No. 2460, Rev. I  
ATA Code 27-50

**SUBJECT:** FLIGHT CONTROLS - INSPECTION OF FLAP DRIVE CABLE/FLAP DRIVE MOTOR COUPLING CONNECTION

**SYNOPSIS OF CHANGE:** Revised Bonanza Model 35 EFFECTIVITY to exclude serials D-1 through D-837; Added 95-55 model designation. Revised ACCOMPLISHMENT INSTRUCTIONS to clarify procedures.

**REASON:** This Service Bulletin is being issued to provide an inspection and instructions for proper attachment of the flap drive cable to the flap motor drive shaft. Improper attachment may result in a split flap condition.

Flap Drive Cable/Flap Drive Motor Coupling Connection  
Figure 1

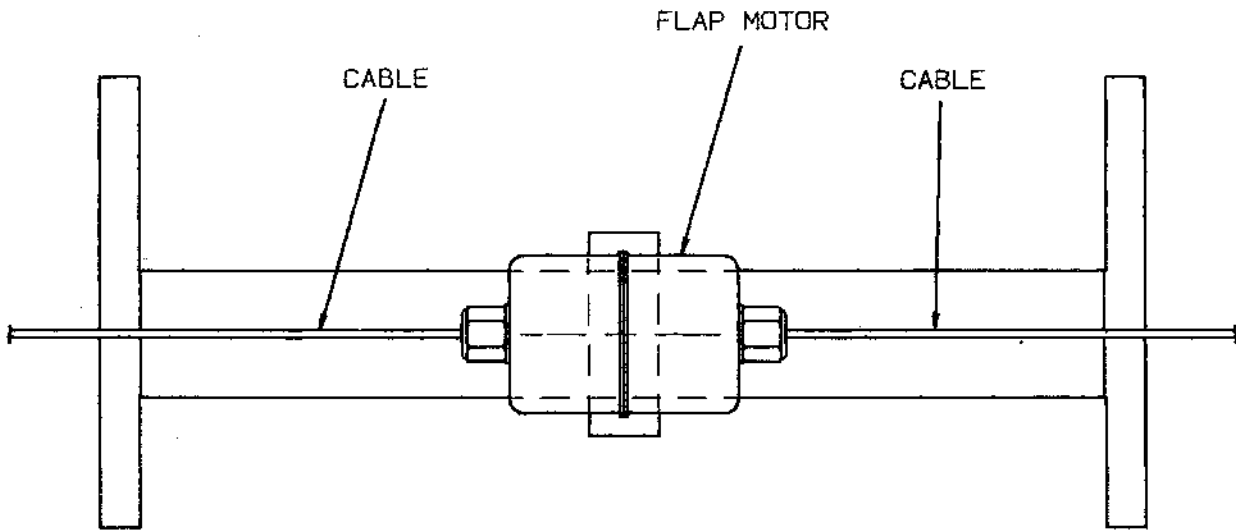
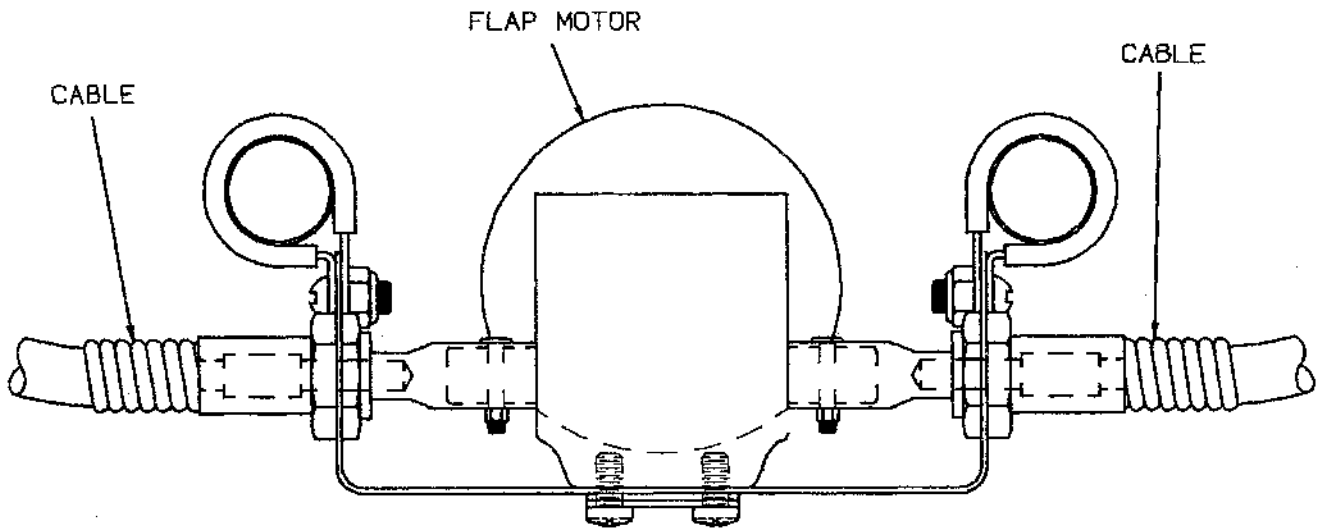
a. The flap drive cable configurations shown in Figure 1 are not affected by this Service Bulletin. If the airplane is configured as shown in View A or View B of Figure 1, proceed as follows:

AIRPLANES WITH EITHER OF THESE  
CONFIGURATIONS ARE NOT AFFECTED  
BY THIS SERVICE BULLETIN.

1) Replace all seats and equipment that were removed to gain access to the flap drive motor.

2) Restore electrical power to the airplane and ensure that the flap system operates properly.

**Flap Drive Cable/Flap Drive Motor Coupling Connection**  
**Figure 2**

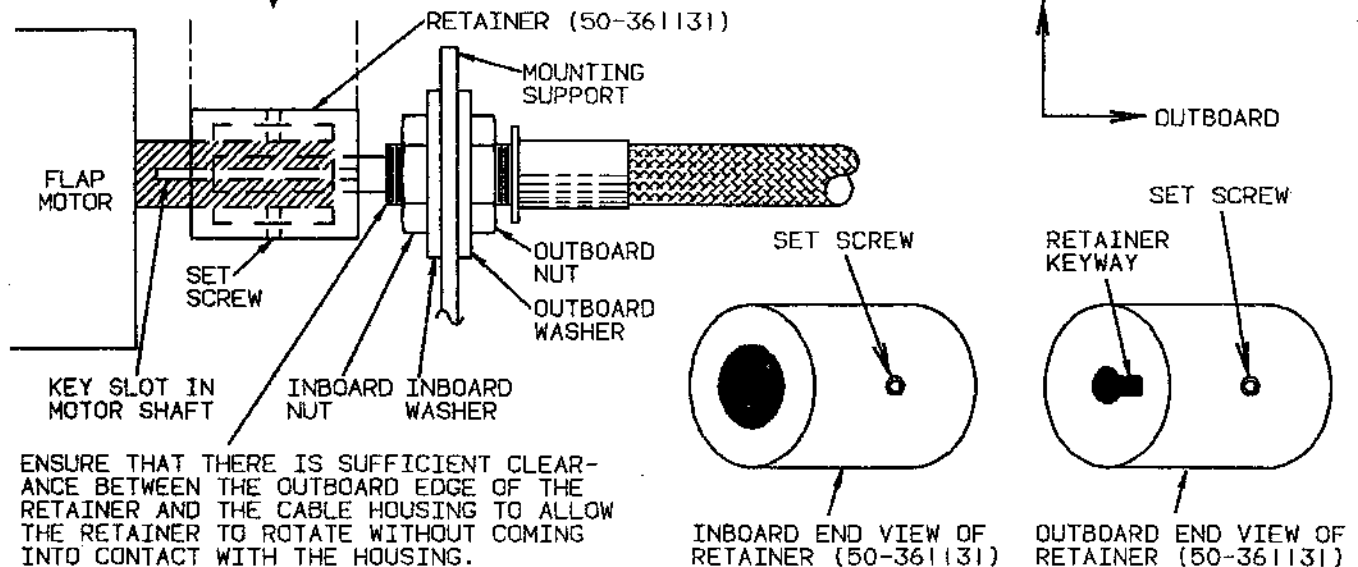
b. If the airplane is configured as shown in Figure 2, proceed to Step 5.

5. Verify that retainers are installed and cable housings and hardware are arranged as shown in Figure 2. Ensure that the keyway slot is rotated 90° relative to the slot in the motor drive shaft. Clearance must exist between the outboard end of the retainer and the inboard

MODEL 60 AIRPLANES ARE EQUIPPED WITH A SPRING IN THIS LOCATION. ENSURE THAT THE SPRING IS INSTALLED.

AIRPLANES WITH THIS CONFIGURATION ARE AFFECTED BY THIS SERVICE BULLETIN.

1. Connect the LH and RH flap drive cables to the flap drive motor as follows, using Figure 2 for component locations:

a. Install the outboard nut and washer as far as it will go on the threaded portion of the flap cable.

b. Insert the retainer through the mount support and onto the motor shaft as far as it will go. Align the retainer keyway with the key slot in the flap motor drive shaft and tighten one set screw temporarily.

c. While inserting the flap cable through the mount support, install the inboard washer and nut. Fully install the cable through the retainer and into the motor drive shaft until the keyway is just past the key slot in the retainer.

d. Loosen the set screw that was tightened in Step b. Ensure that the retainer is still installed on the motor shaft as far as it will go and rotate the retainer 90°.

e. Keep inboard pressure on the retainer and tighten both retainer set screws.

f. Secure the flap drive cable to the mounting support by tightening the nuts. Tighten the inboard nut to ensure that there is sufficient clearance between the out-

board edge of the retainer and the cable housing to allow the retainer to rotate without coming into contact with the cable housing. If the threaded part of the cable housing is not long enough to install the two nuts and washers, using a die, add 5/8-24 UNEF threads until .88 inch thread length is reached. Tighten the outboard nut against the mounting support.
